Subject: Operations Maintenance Facility: East – Bulletin No. 0032

Bulletin No.	Description	Importance	Cost
0032	PCC Pavement at MOW	Normal	Unanticipated

PROJECT: LINK OPERATIONS & MAINTENANCE FACILITY: EAST**STANTEC PROJECT NO:** 204820133**DATE:** 12/12/2019**CONTRACT NO.:** RTA/CN 002-16**ORIGINATOR:** JIM MCPHERSON**DISCIPLINE:** CIVIL

Subject: Design bulletin DB032 for DP2 changes

DRAWING No.:
Y02-CPP206
LOCATION ID:
Y02
SHEET No.:
REV:
A

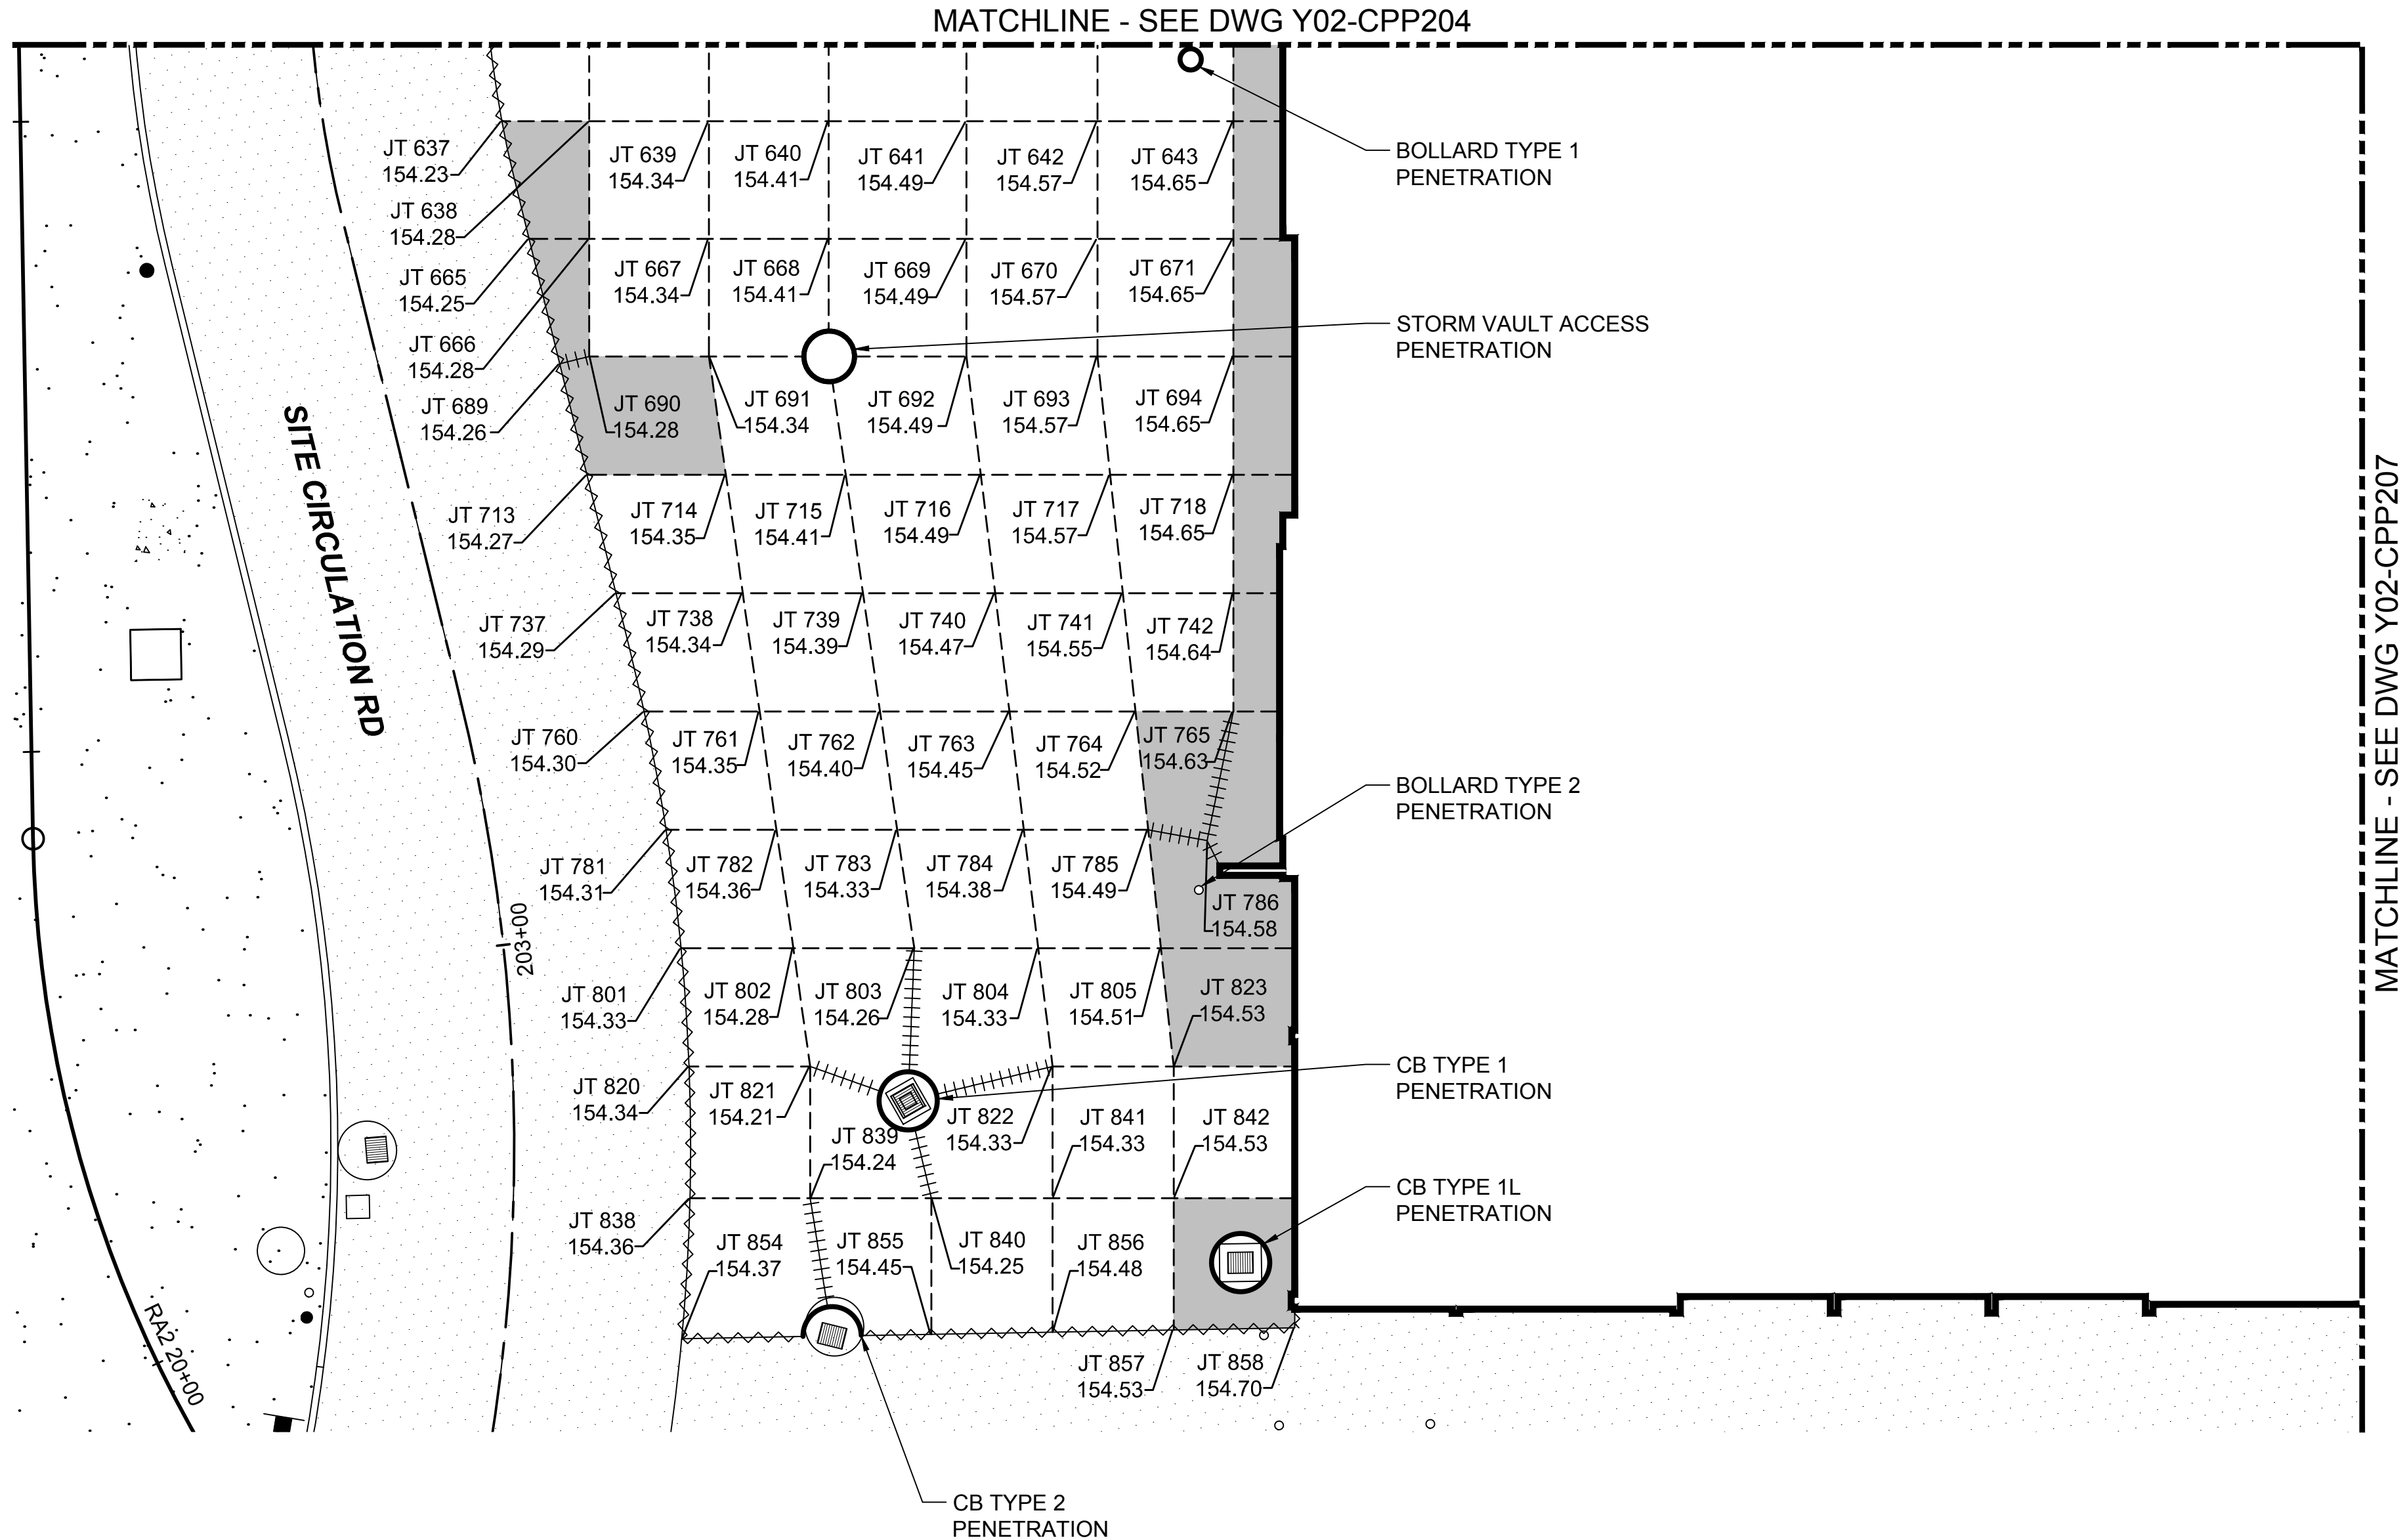
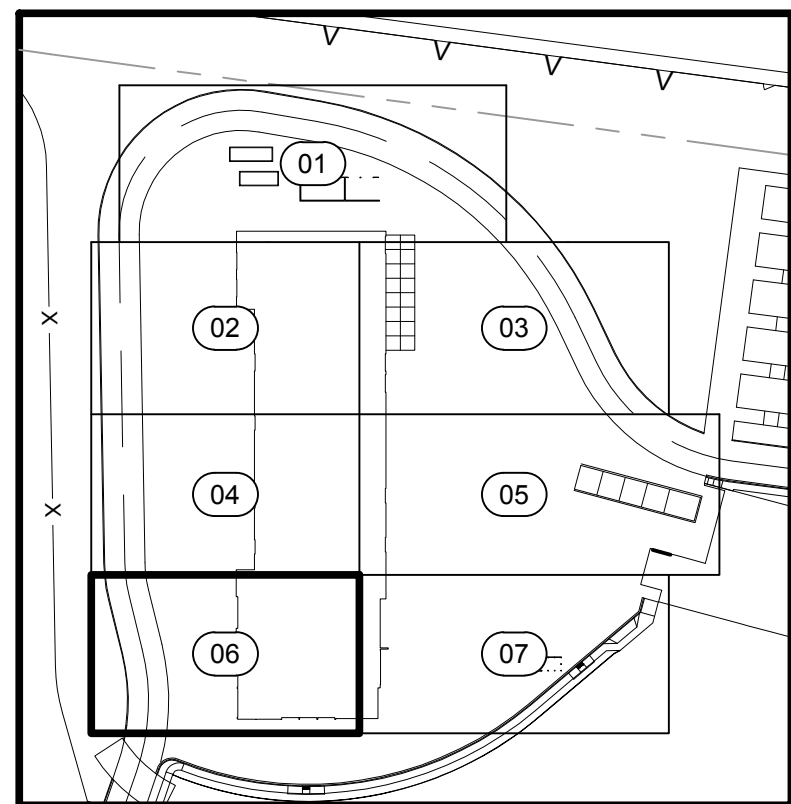
VARIOUS ELEVATION CHANGES,
SEE CLOUDS ON POINT TABLES.

DRAWING No.:
Y02-CRD112
LOCATION ID:
Y02
SHEET No.:
REV:
C

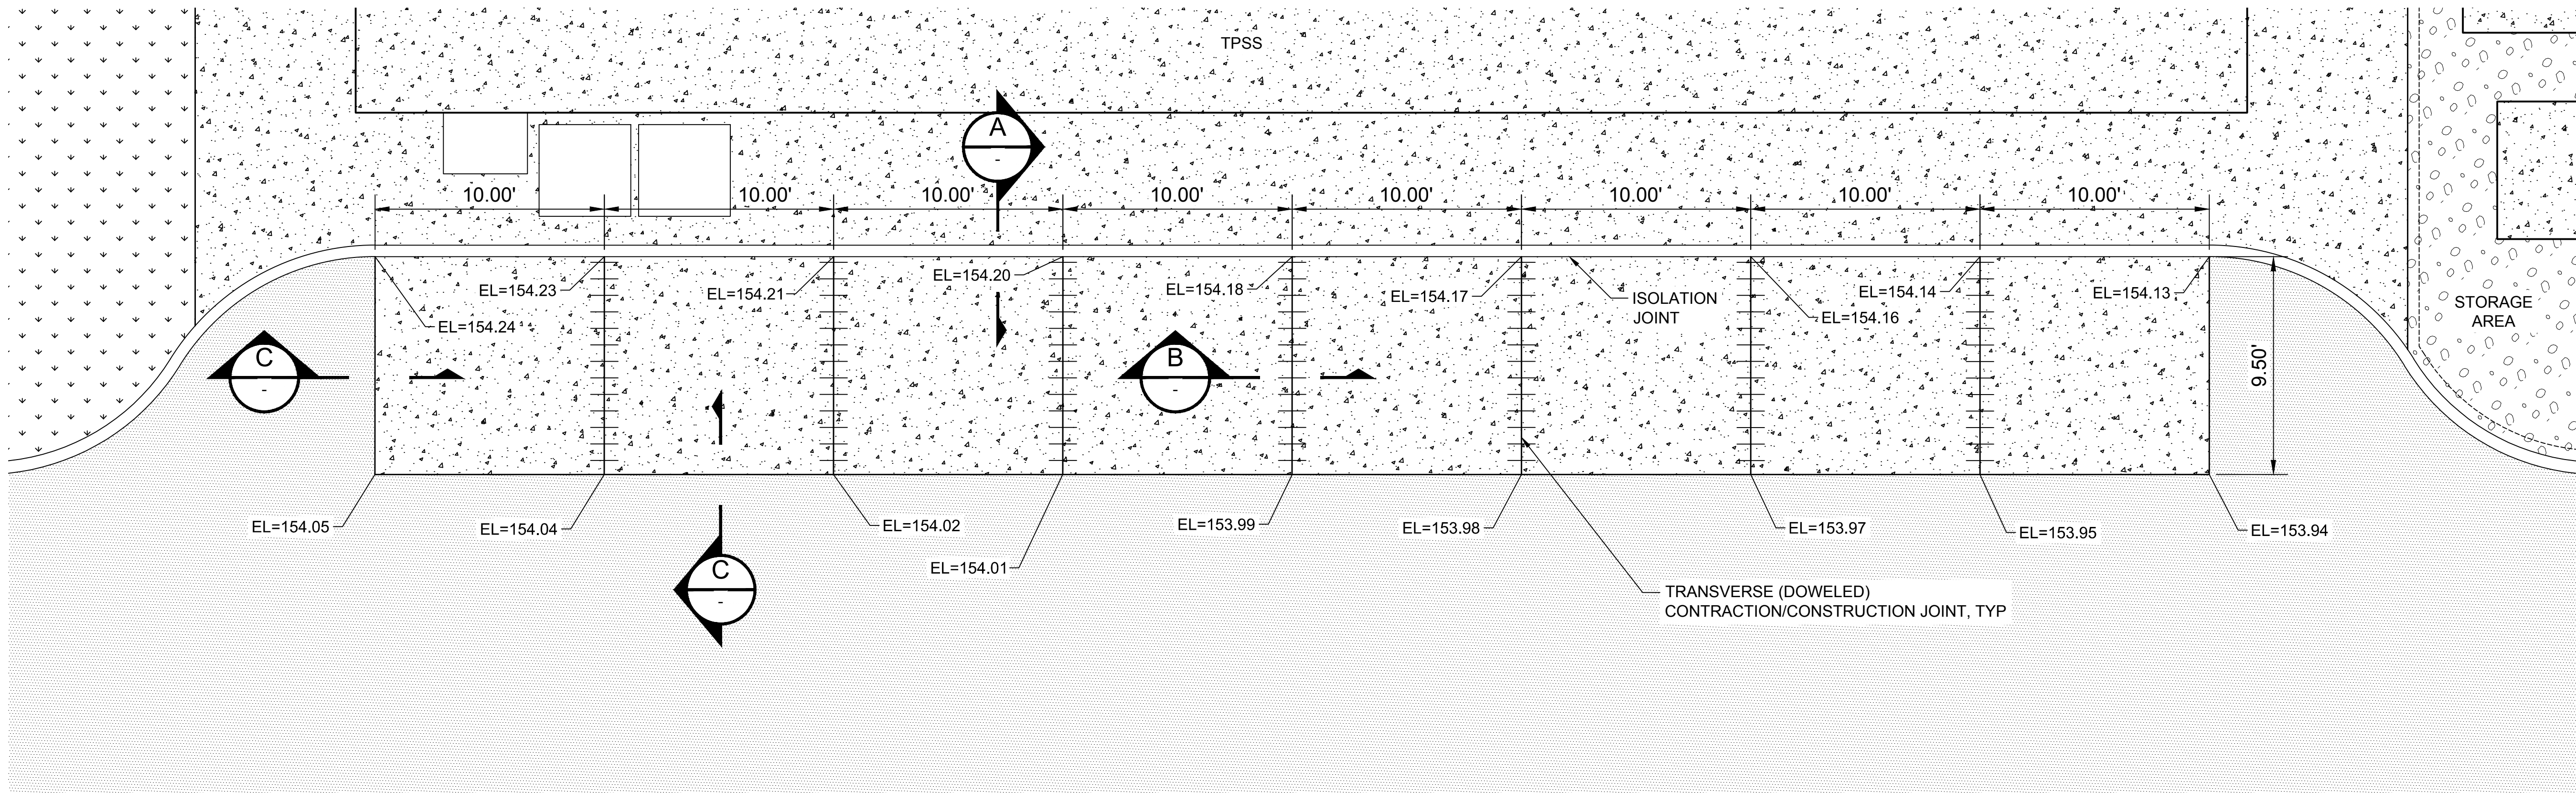
Y02-CRD112 – Update drawing to show PCCP (UPDATED ELEVATIONS)

DRAWING No.:
Y02-CRD118
LOCATION ID:
Y02
SHEET No.:
REV:
C

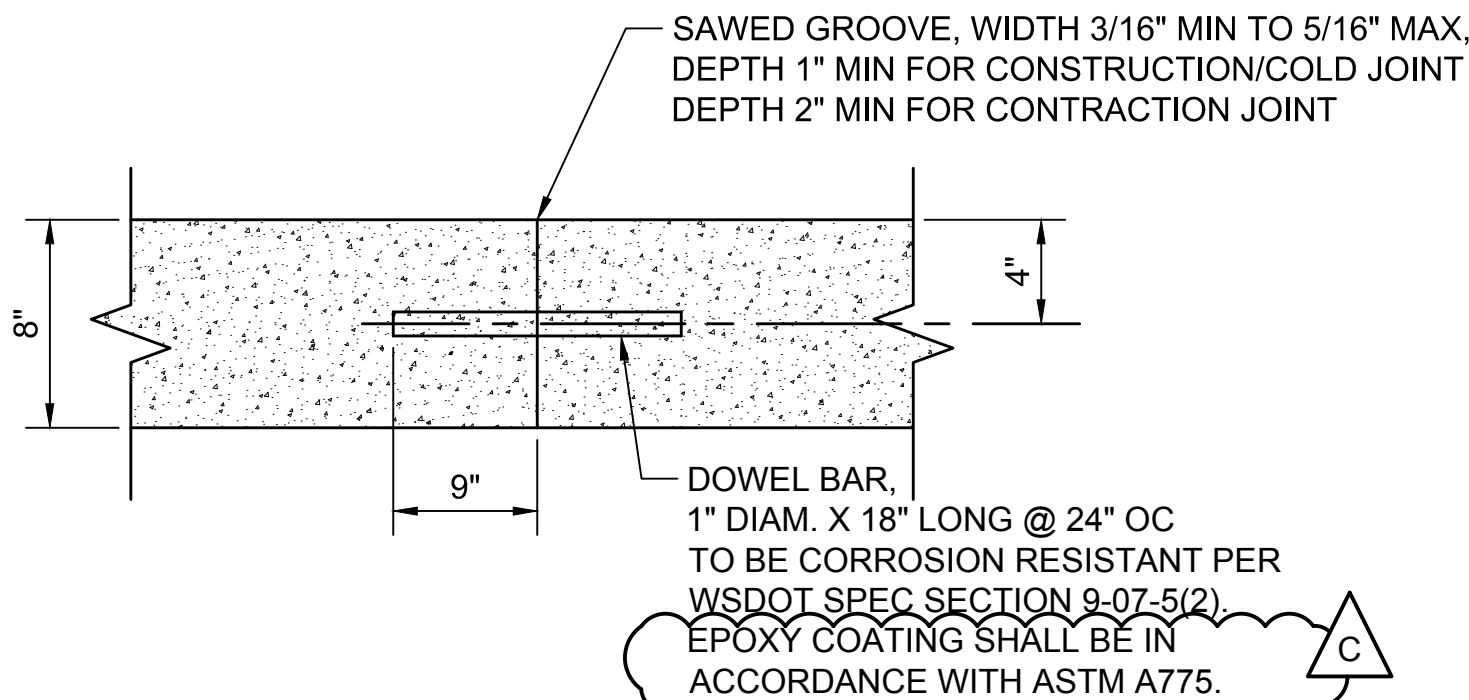
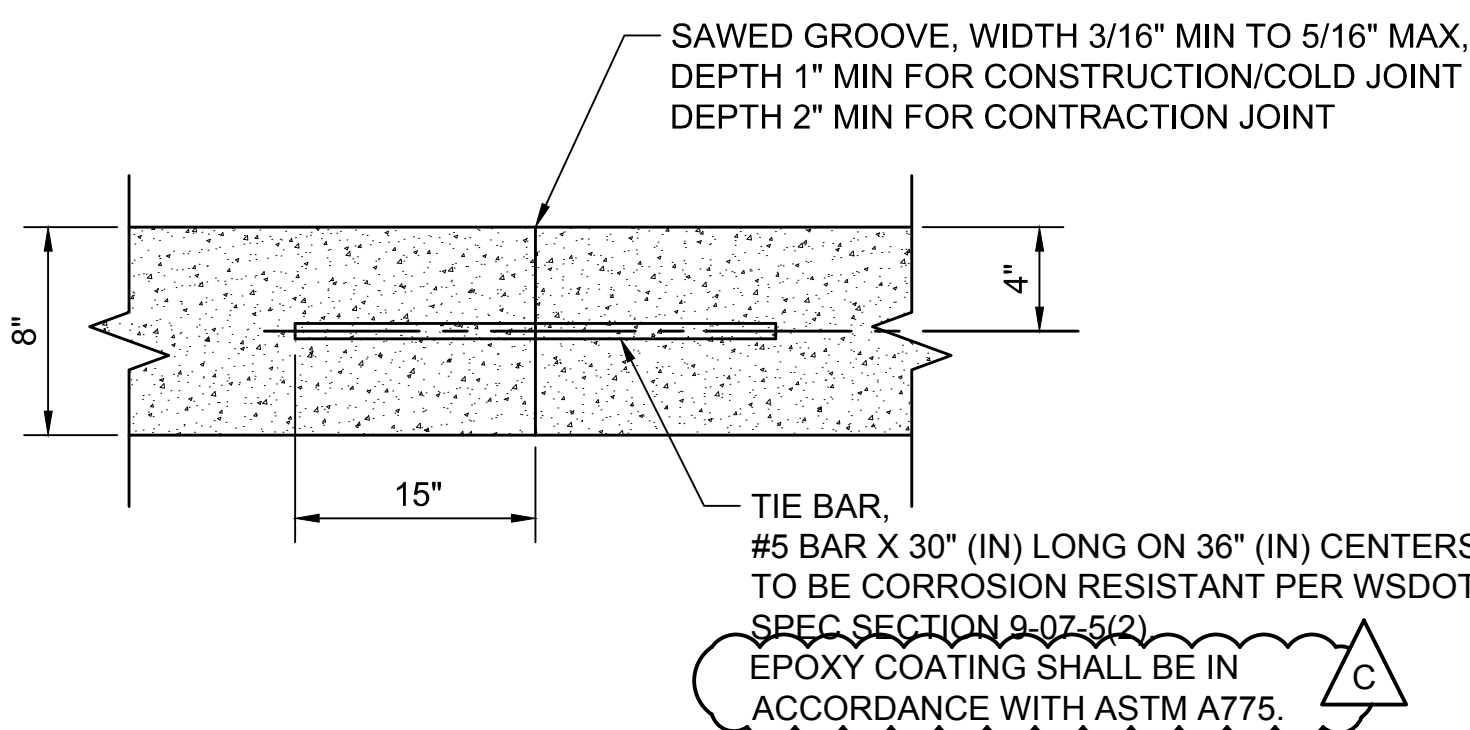
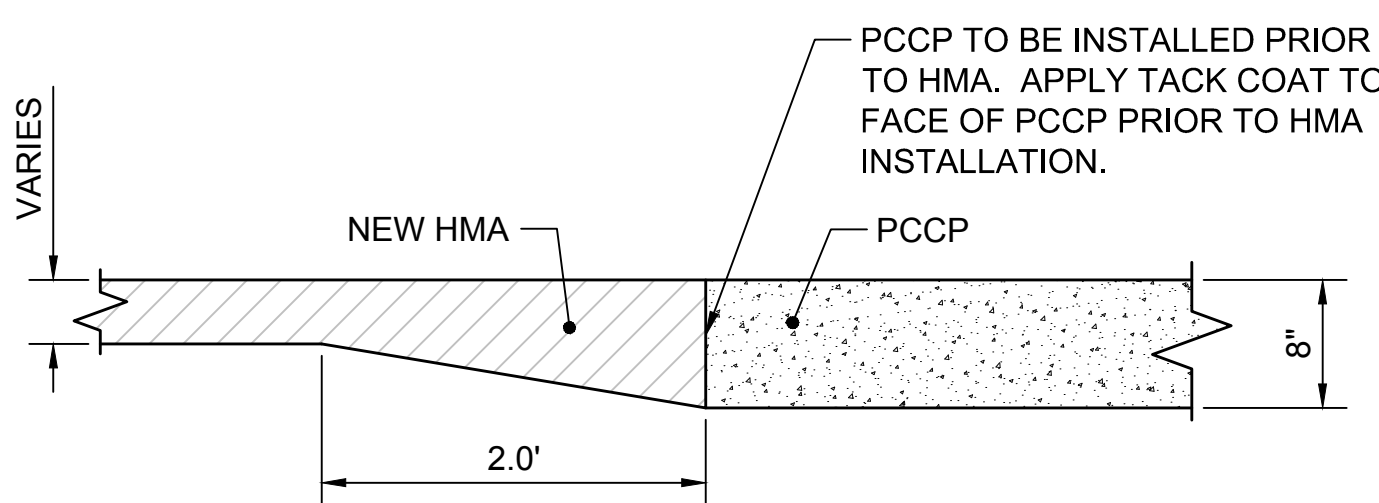
Y02-CRD118 – Update drawing to show PCCP (ADDED EPOXY COATING SPEC CALL-OUT)
